DEVELOPMENT APPLICATION ASSESSMENT REPORT

Application Number:	DA2025/0136
----------------------------	-------------

Responsible Officer:	Anaiis Sarkissian
Land to be developed (Address):	Lot 56 DP 7794, 60 Hudson Parade CLAREVILLE NSW 2107
Proposed Development:	Construction of a boat shed, waterway access stairs and landscaping
Zoning:	C4 Environmental Living
Development Permissible:	Yes
Existing Use Rights:	No
Consent Authority:	Northern Beaches Council
Land and Environment Court Action:	No
Applicant:	Oliver Hartley

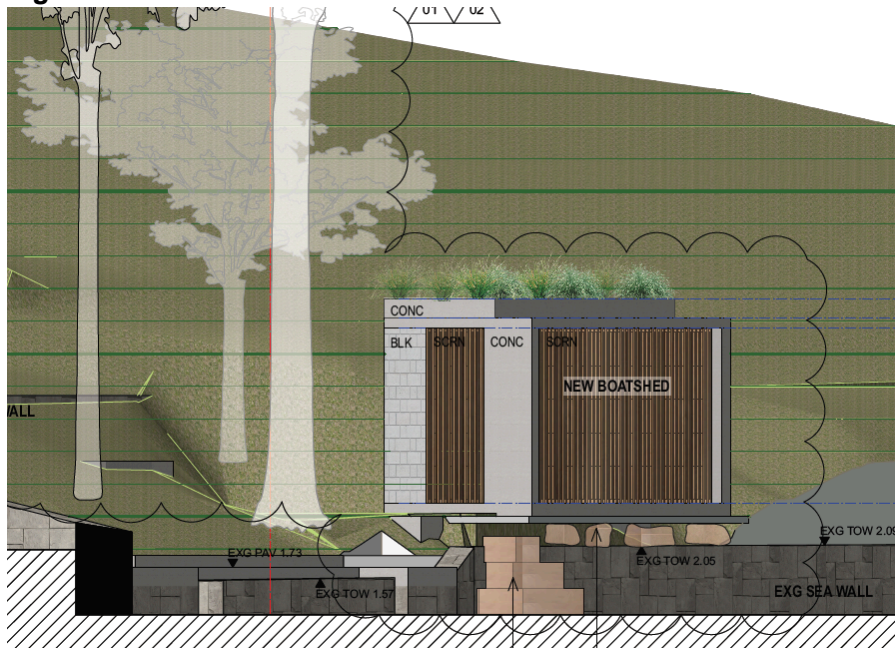
The submissions originally raised concerns over the height, bulk and scale of the proposal; however in response to the amended design, it was considered that the proposal presents a satisfactory level of bulk and scale.

The amended proposal presents a significantly reduced footprint with a building height well below that permitted for boat sheds. The amended boat shed also sits 200mm lower than the original design, both at the floor level and the ridge level. Tree 17 is now also proposed to be retained in addition to Trees 15 and 16, thereby having no negative visual impact on the foreshore from the Pittwater waterway. Figure 1 and 2 below demonstrate the significant reduction in bulk and scale of the amended design compared with that originally proposed.

Figure 3: Original design

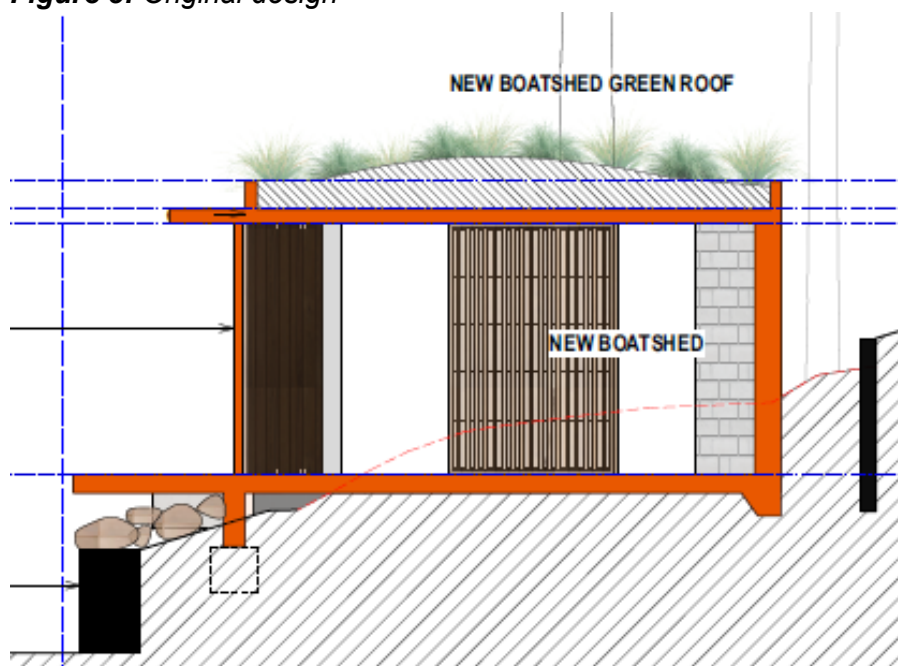
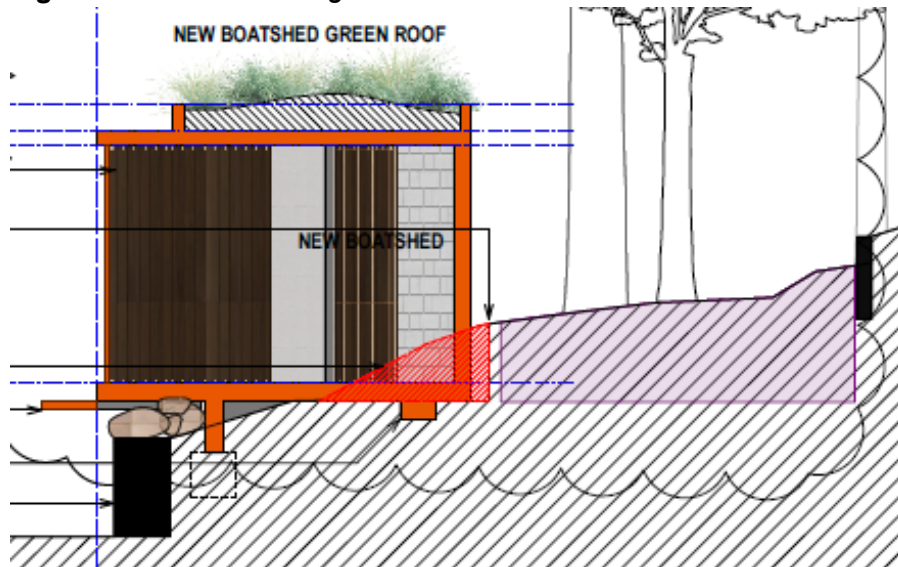
The submissions raised concerns over the extent of proposed excavation to accommodate the proposed boat shed.

The amended proposal significantly reduces the footprint of the boat shed, thereby reducing the extent of excavation required, as evident in Figures 3 and 4 below.

Figure 6: Proposed floorplan

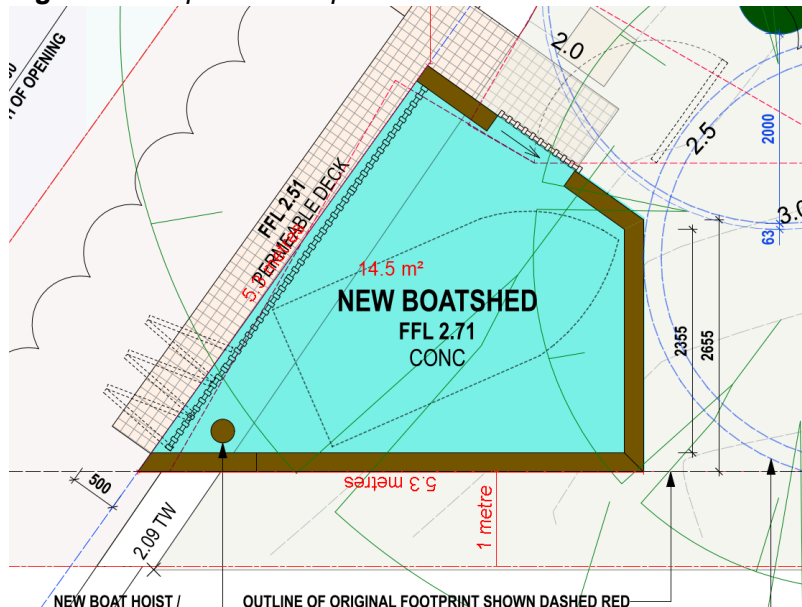
The proposed boat shed is located above the mean high water mark on freehold land. The boat shed is one storey and has a building height of 3.15m above the platform on which it is proposed to be built. The amended boat shed design has a width of 5.3m and a maximum length of 5.3m, and therefore does not comply with the maximum width of 4m. The boat shed does not hinder public foreshore access and is to be used only for the purpose of storing small boats and/or boating equipment. The roof area of the boat shed is proposed to be a non-trafficable green roof planted with native vegetation, and the boat shed is to be constructed of materials that respond sensitively to the surrounding setting and natural landscaped character of the area. A condition has been included within this consent requiring the roof to not be constructed of a reflective material or finish. The floor level of the boatshed is at 2.71m AHD, which is not lower than the Estuarine Planning Level of 2.71m AHD, and the proposed boat shed is able to be fully enclosed.

In relation to the variation in maximum width of the boat shed, it is important to note that the boat shed only measures 5.3m to one end; the other end is 2.7m wide (refer Figure 6 below). The boat shed is irregularly shaped and has been designed to avoid long-term impact on the surrounding trees. Furthermore, it is noted that the boat shed at 66 Hudson Parade measures approximately 4.8m in width. The Pittwater 21 Development Control Plan allows for a boatshed that measures a maximum of 4m x 6m, which effectively allows for a boat shed with a maximum footprint of 24m²; the proposed boat shed has a significantly smaller footprint of 14.5m². Additionally, the choice of materials and colours means that the boat shed does not unreasonably dominate the foreshore (refer Figure 7 below).
